SHOCK ABSORBER CHANGE — 1965 ELECTRA-GLIDE AND SPORTSTER H

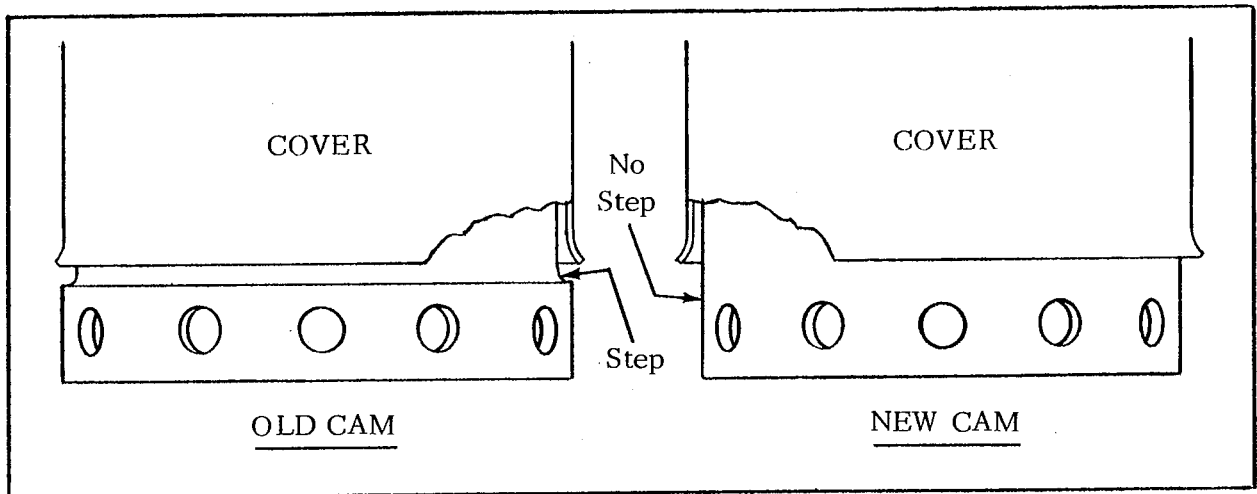
The adjusting cam used on the 1965 covered type shock absorbers have been changed by reducing the diameter to eliminate the step at the bottom end. This prevents contact between cam and cover when the shock telescopes to the compressed position.

The illustration below shows the change made in the lower adjusting cam.

The factory recommends replacing all early type rear shock cams on 1965 motorcycles in your possession immediately. If motorcycles have already been delivered to customers, replace cams on these motorcycles at your earliest opportunity.

To replace lower cam, remove one shock absorber from the motorcycle at a time, and using shock absorber tool, Part No. 97010-52, compress shock spring enough to turn lower stud eye 90° and remove cam. Details on this operation are described in Section 2F of the Service Manual.

Order the number of new cams, two per motorcycle, which you will require for replacement under Part No. 54529-56A.
